Project: East-West Bus Rapid Transit

Contract No.: 8716  
Enactment No.: RES-23-00028  
Dollar Amount: 65,743,246.27

**File #:** 75225      **Version:** 1      **Name:** Awarding Public Works Contract No. 8716, East - West Bus Rapid Transit.  
**Type:** Resolution      **Status:** Passed  
**File created:** 12/16/2022      **In control:** Engineering Division  
**On agenda:** 1/17/2023      **Final action:** 1/17/2023  
**Enactment date:** 1/18/2023      **Enactment #:** RES-23-00028

60631225P  
P25-E

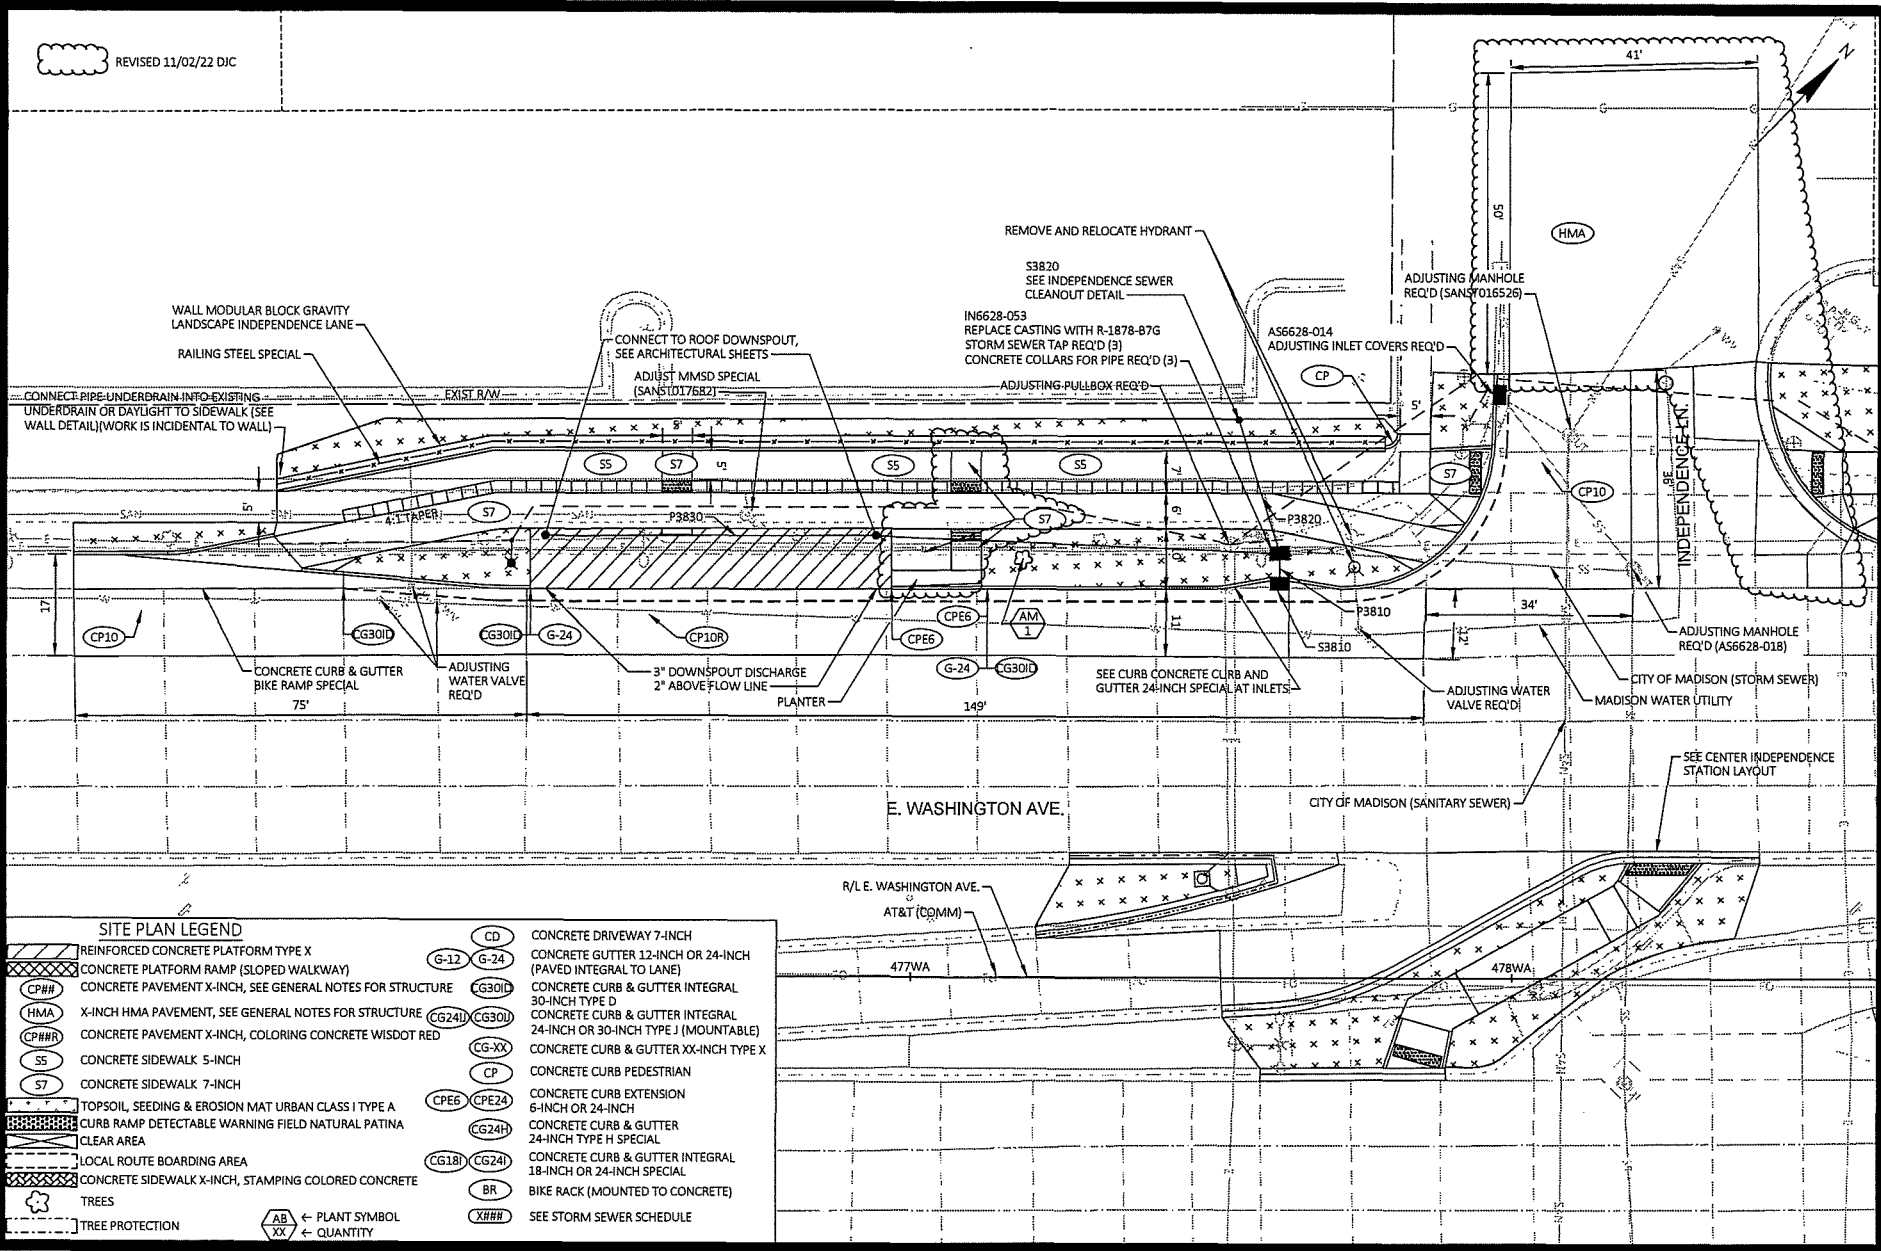
SHEET P25-E (REV 11/02/2022): Modified HMA/concrete pavement area to show increased replacement required for tie in and added sidewalk label.

60631225P  
 P26-E

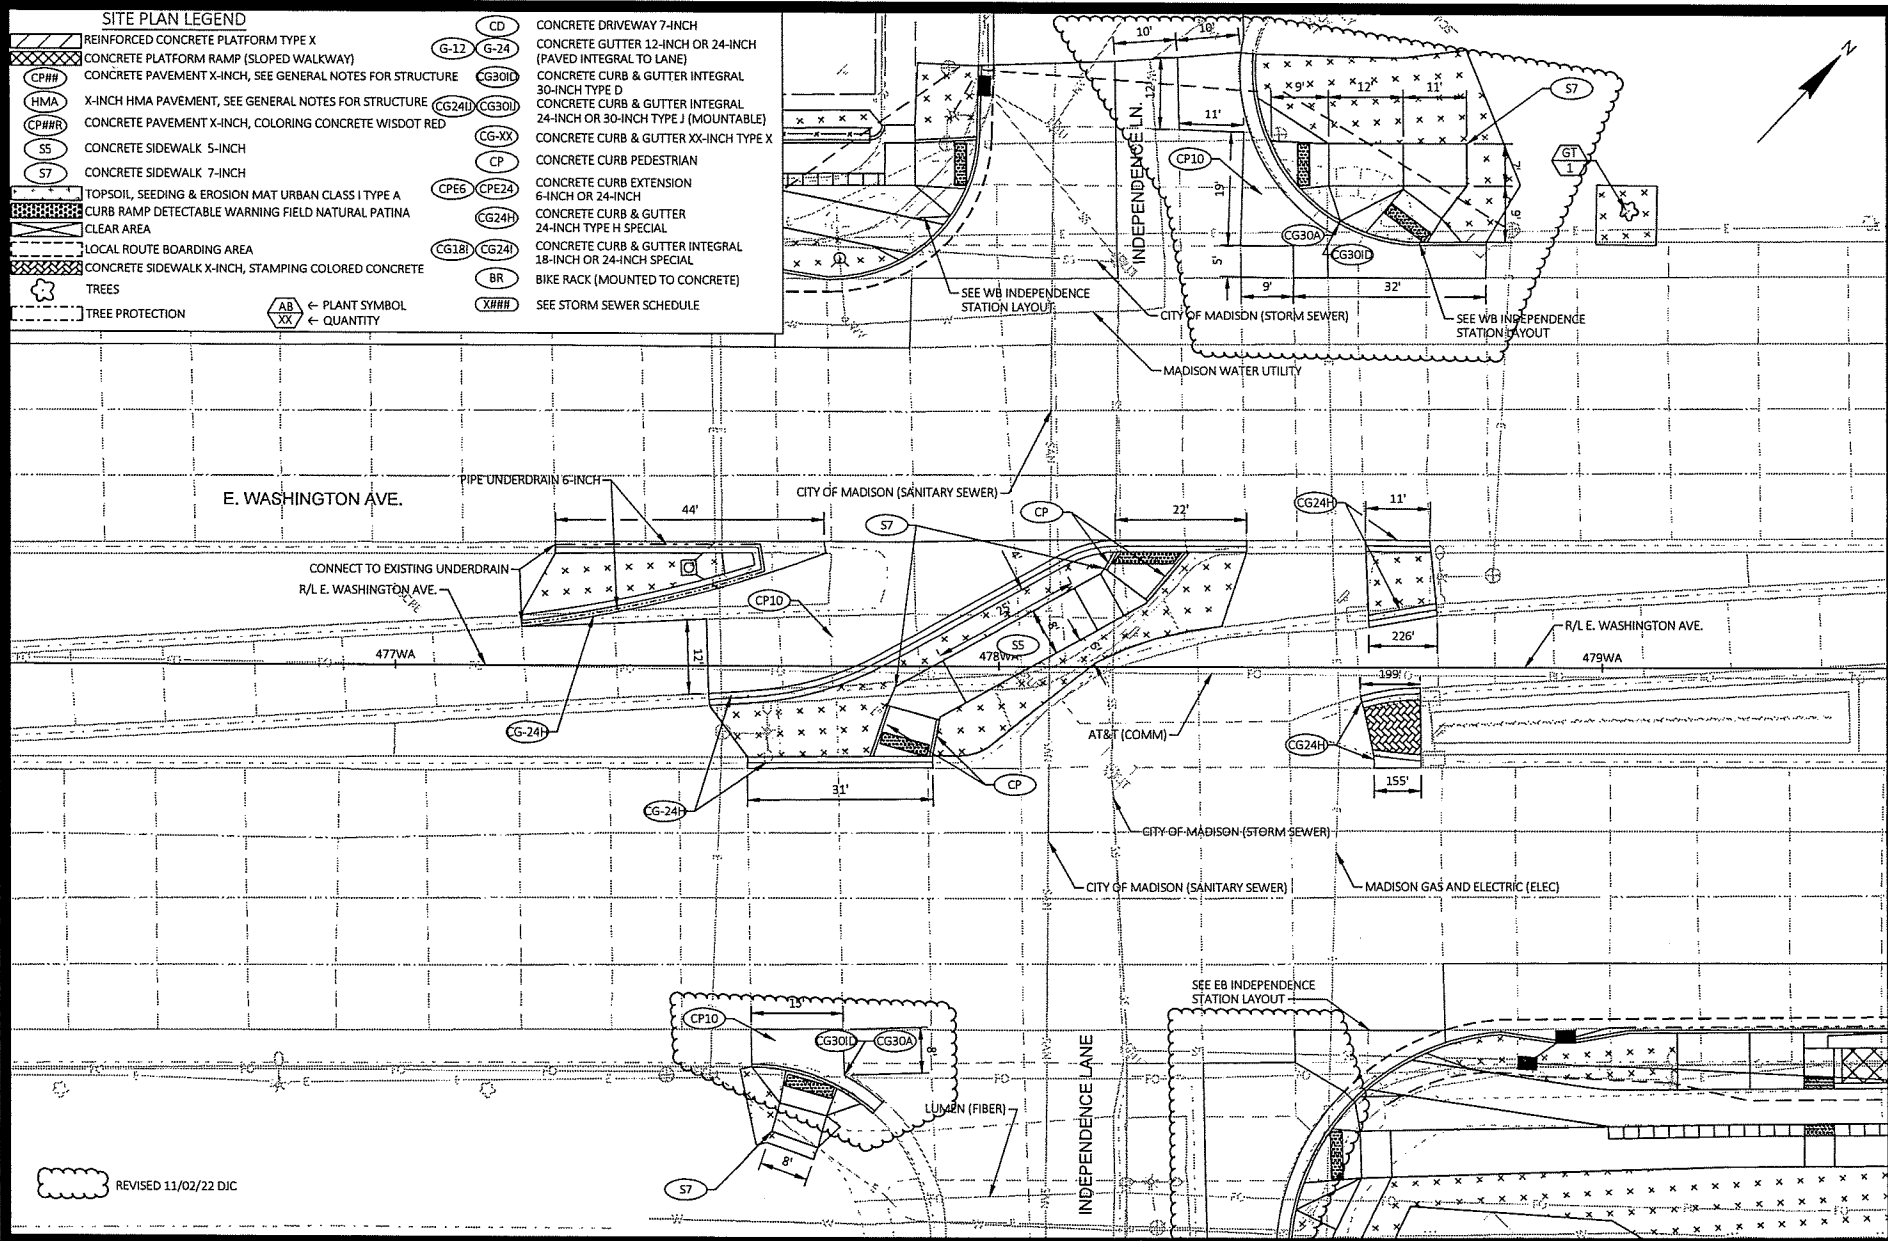
SHEET P26-E (REV 11/02/2022): Modified HMA/concrete pavement area to show increased replacement required for tie in.

60631225P  
 CITY OF MADISON, DANE COUNTY, WI  
 BUS RAPID TRANSIT  
 CITY OF MADISON  
 60631225P  
 P26A-E  
 CONTRACT NO: 60631225C  
 ADDRESS: 3  
 REVISION: 1  
 DATE: 1/22/22  
 D.C. BY: [blank]  
 SCALE: 1"=20' FT  
 DESIGNED BY: [blank] DATE: 2022-11-08  
 DRAWN BY: [blank]

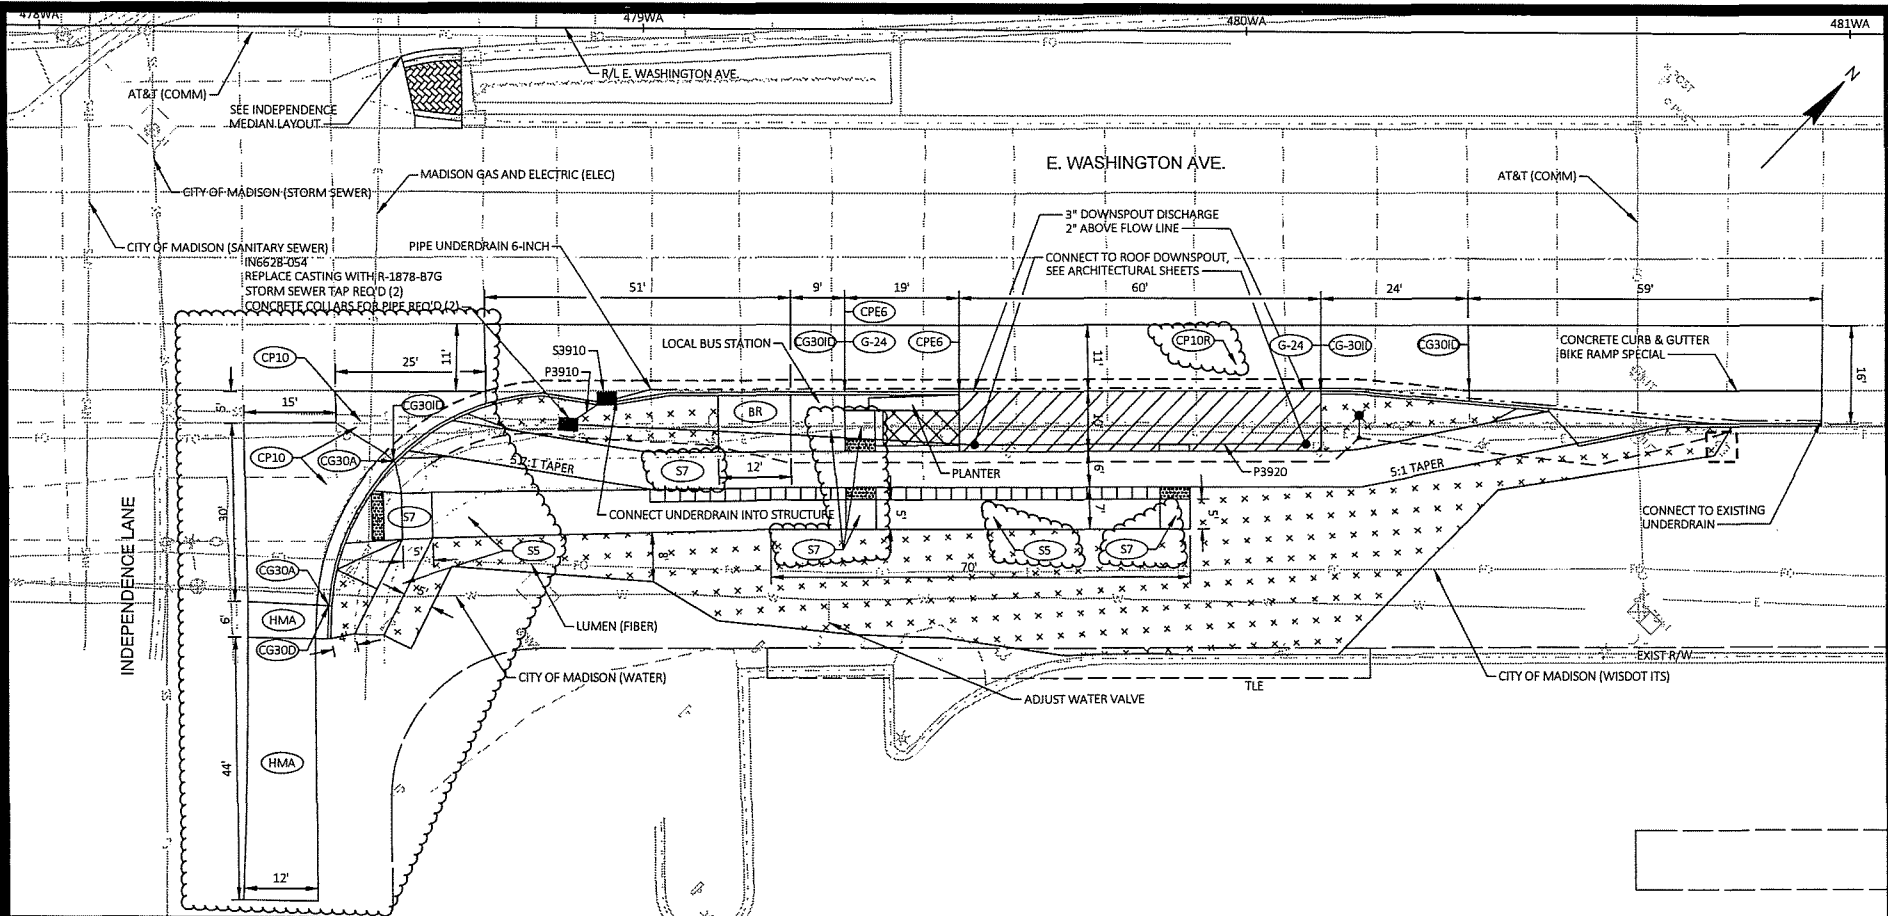
SHEET P26A-E (REV 11/02/2022): Linework updated based on new limits.

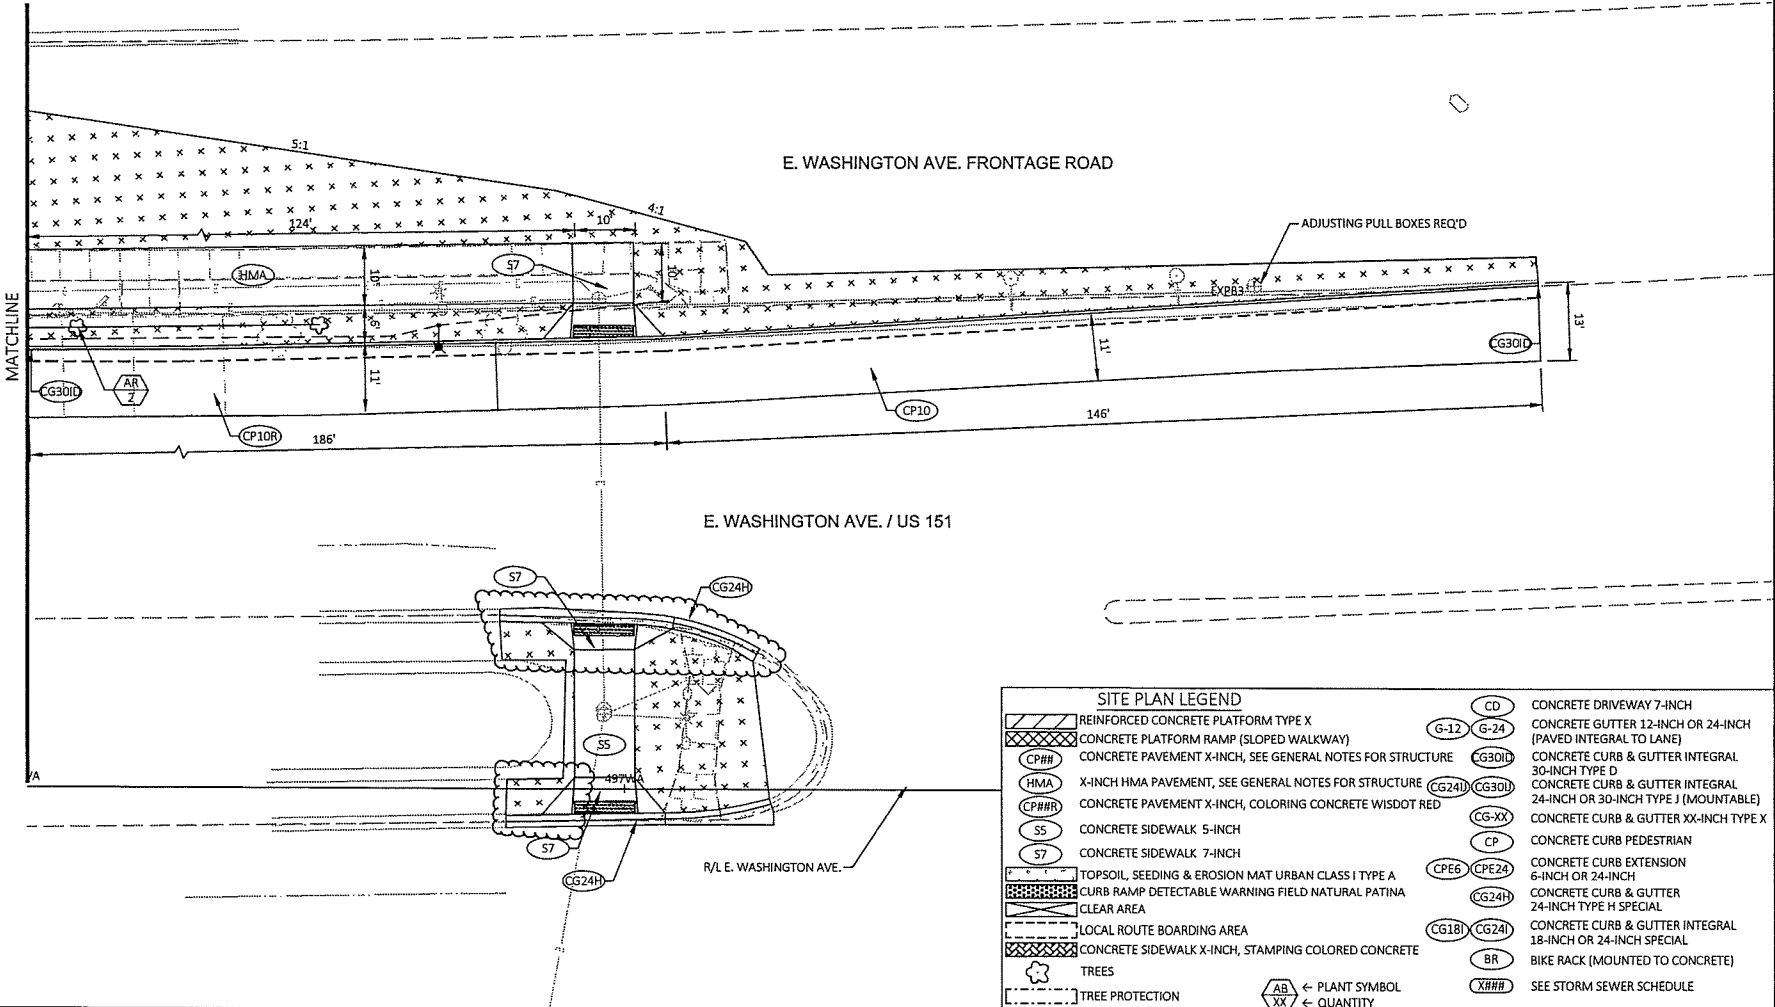
SHEET P28-E (REV 11/03/2022): Modified to add sidewalk labels for added clarity.

60631225P  
G29-E

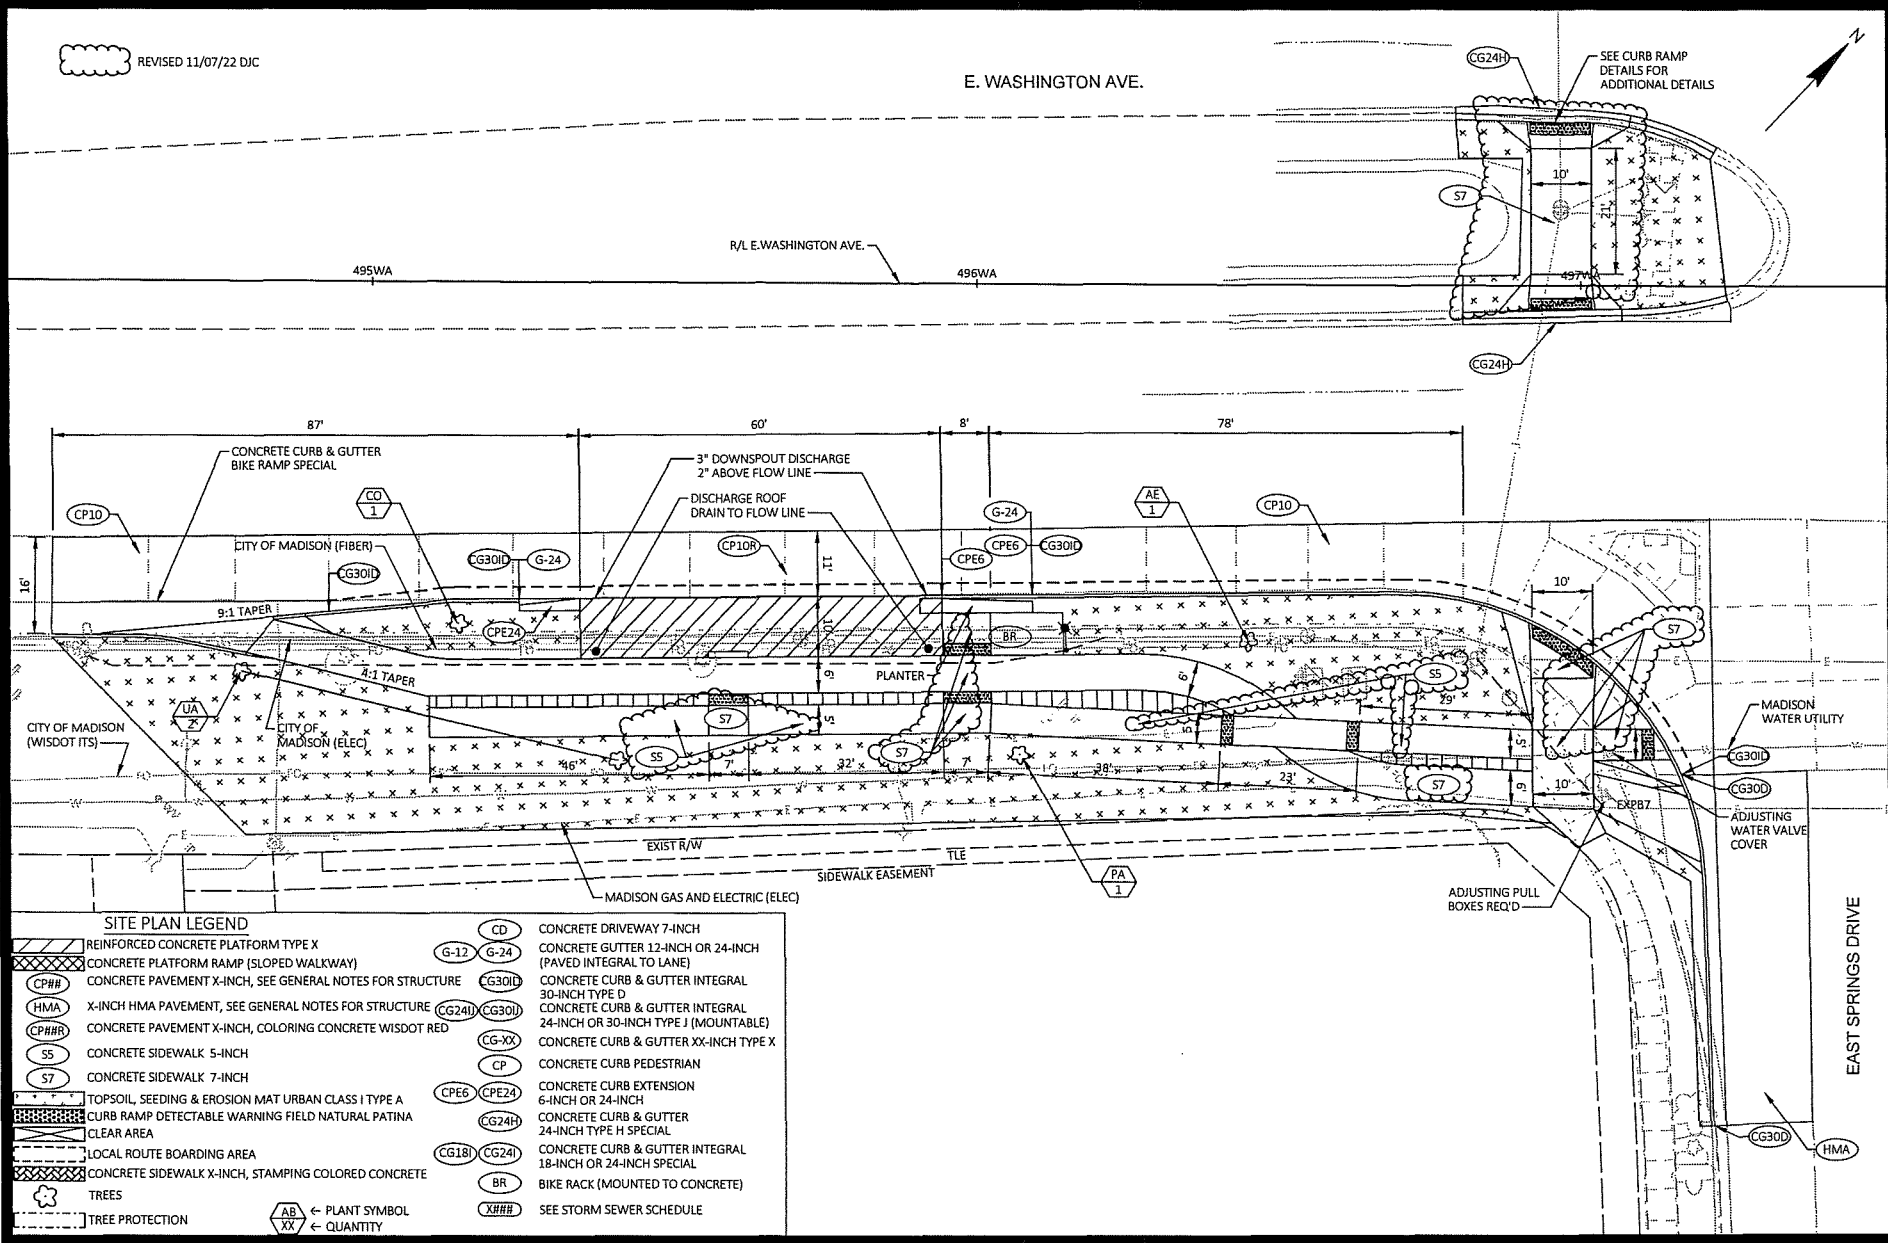
SHEET G29-E (REV 11/03/2022): Added slope labels for additional clarity.

**4 DETAIL AT PLATFORM - CONCRETE SLOPED SIDEWALK CONNECTION**  
1" = 1'-0"

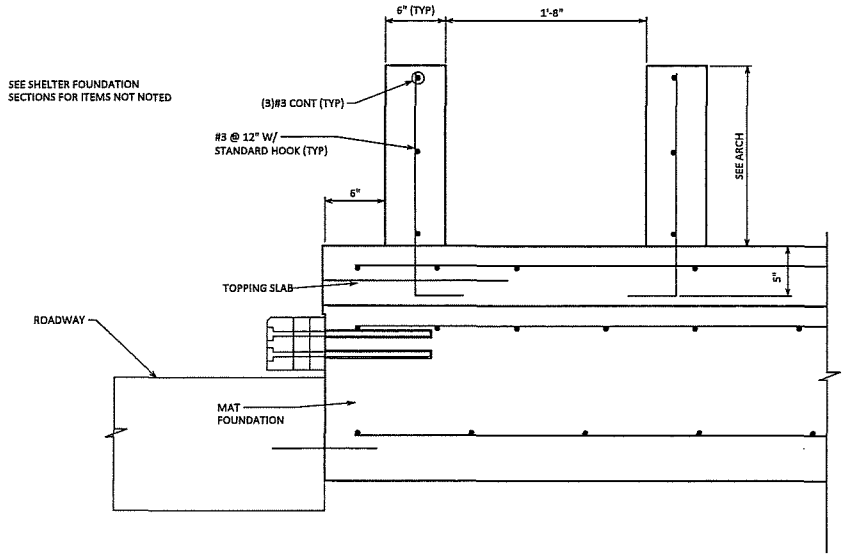
SHEET S-S301 (REV 11/07/2022): Updated detail 4 to include dowel between concrete sloped walkway and sidewalk or curb ramp.
